TOWN OF JAMESTOWN
ZONING BOARD OF REVIEW

Application for Exception or Variation under the Zoning Ordinance

Office of the Town Planner
MEMORANDUM

TO: Jamestown Zoning Board of Review
FROM: Lisa Bryer, AICP Town Planner for The Jamestown Planning Commission
RE: Motion for Zoning Section 82-800: High Groundwater Table and Impervious Overlay District, Sub-District A; Duva Residence at 509 Seaside Drive, Jamestown, RI
DATE: October 7, 2024

DRAINAGE PLAN

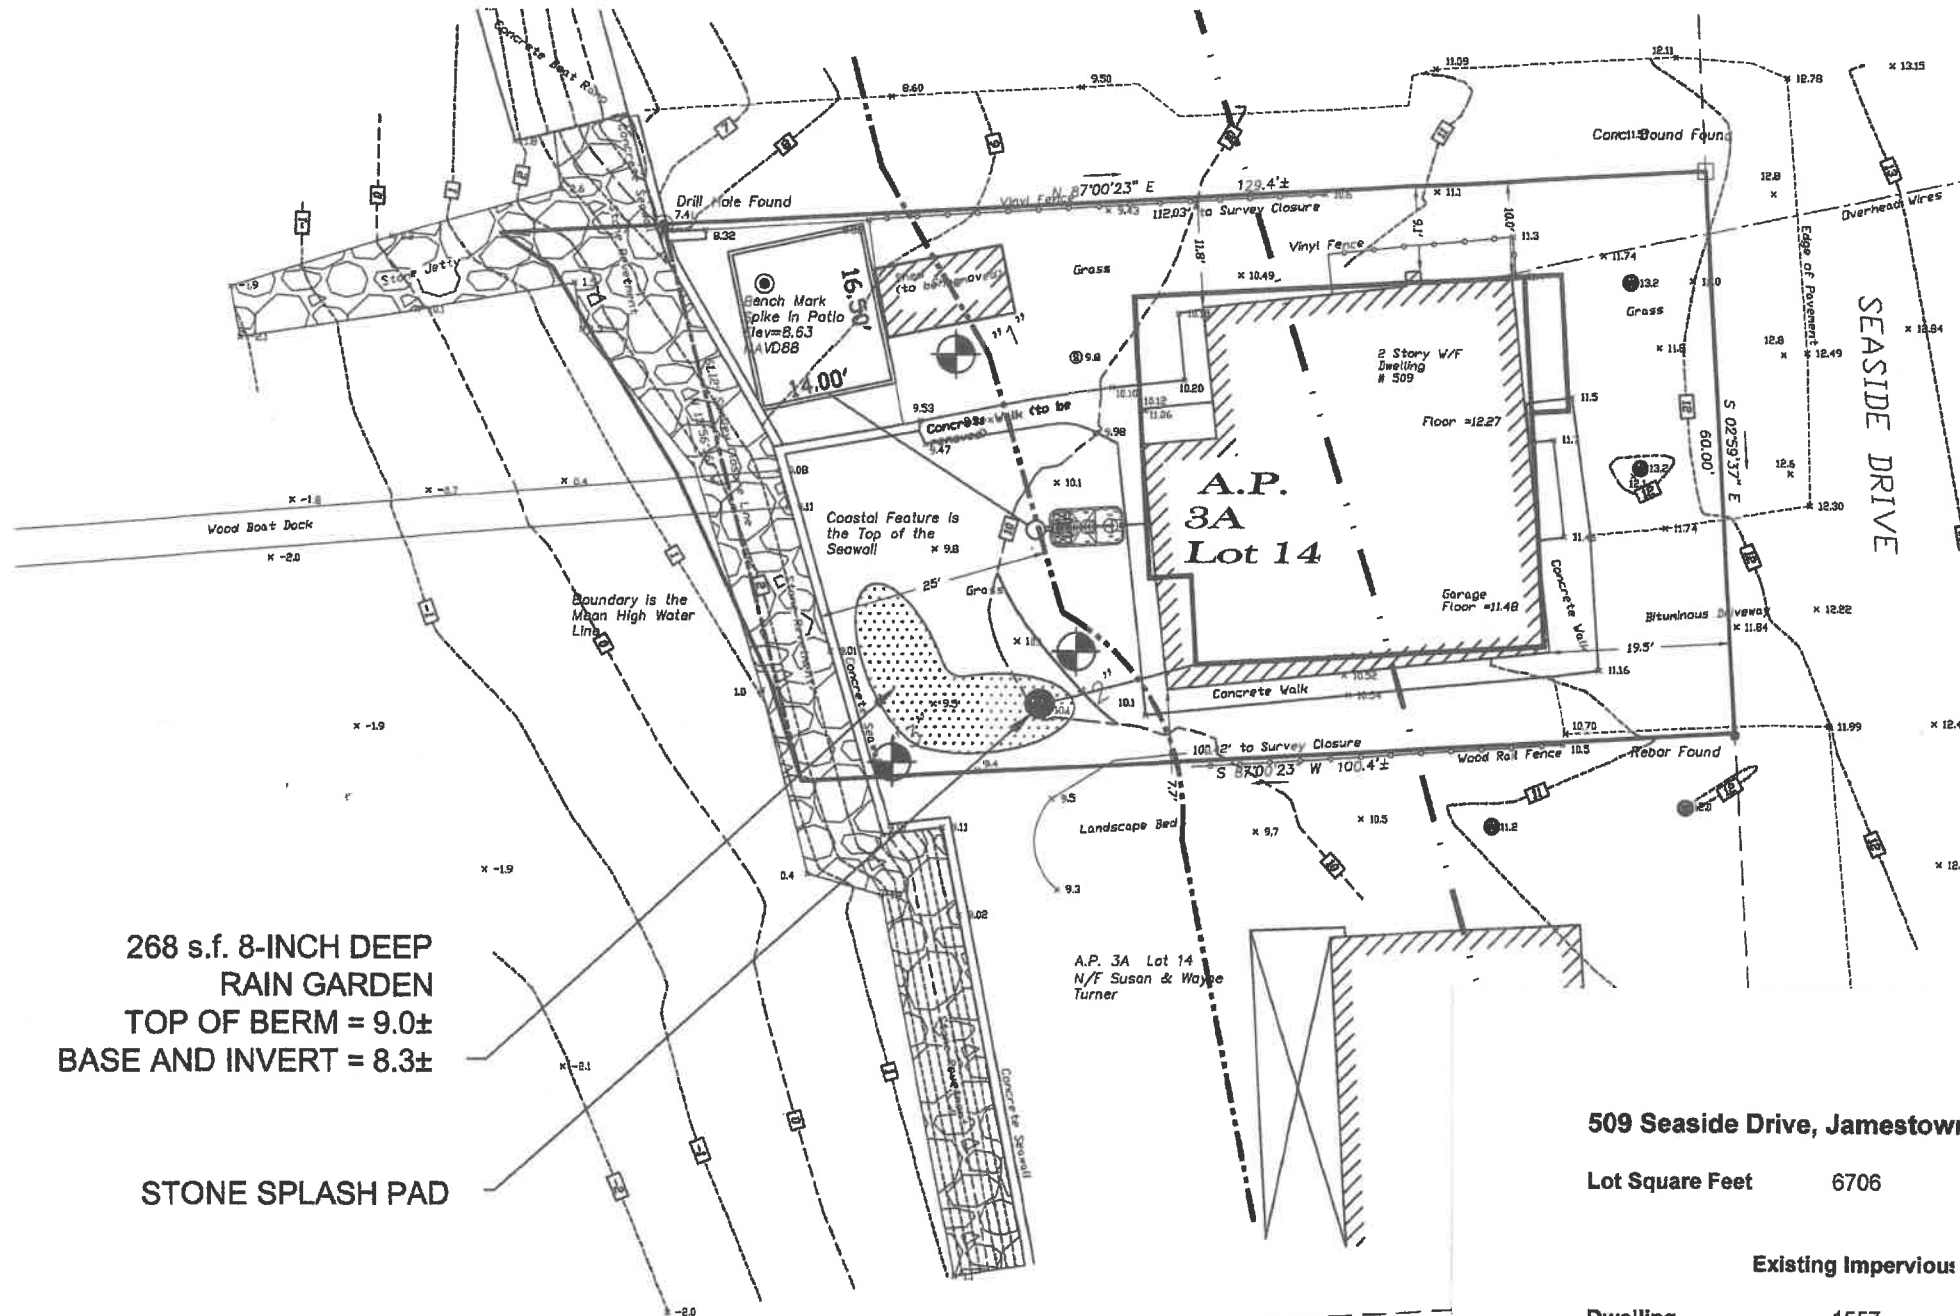
The property is 6706 square feet (sf) in area. The existing site is developed with a house, dock, shed, patio and paved driveway (total existing impervious area is **2,841 sf or 42.4%**). Topography on the lot slopes from east to west (towards Narragansett Bay) on the site. There are no freshwater wetlands on the property; the CRMC coastal feature is the top of the bluff and there is a 25' CRMC coastal buffer.

Soil evaluation results show that the site falls under **Sub-district "A"** requirements of the High Groundwater Table and Impervious Overlay District with 10" to the seasonal highwater table and 68" to impervious soil. The maximum impervious cover allowed is 9.0% or 604 sf.

The applicant is proposing to demolish the existing house and remove the existing impervious driveway, impervious walkways, and shed. A new 1674 sf house with a pervious driveway is proposed. The total proposed area impervious is **1,674 sf (24.96%)**. A new OWTS (RIDEM #0415-0543: 3-bedroom Fujiclean to BSF) will be installed. The new owts is replacing a cesspool.

There is a **1,167-sf reduction** in impervious surfaces on the site. The applicant has proposed a rain garden for stormwater mitigation of the CRMC required water quality. A detail for the rain garden has been submitted with the site plans.

- **The applicant proposes a substantial reduction in impervious cover, is installing a nitrogen reducing owts, and is providing stormwater runoff mitigation and treatment.**
- The site must comply with zoning setbacks.
- A minimum separation of 12" from the SHWT to the bottom of the slab is required. Basements are not allowed in Sub-district A structures.
- Erosion and sediment controls must be installed at the down gradient limits of site disturbance and maintained until stabilization of the site is attained.
- After installation, maintenance and inspection of the OWTS shall continue as required by the Town.
- Any additional future site work that increases the area of impervious coverage will require a review following the requirements of the High Groundwater Ordinance.
